**MEYLE**<sup>®</sup>  
Products

## Control arm bushing to fit BMW E53 (X5)

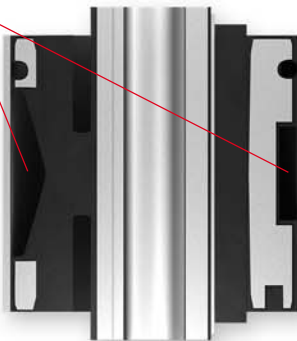
### Problem

High dynamic strain causes leakage of the hydro-liquid

### Effect

- Vibration in the steering
- Reduced driving comfort

Replacing the hydro mount with a full rubber mount

No leakage possible and significant longer lifetime without restriction of driving comfort
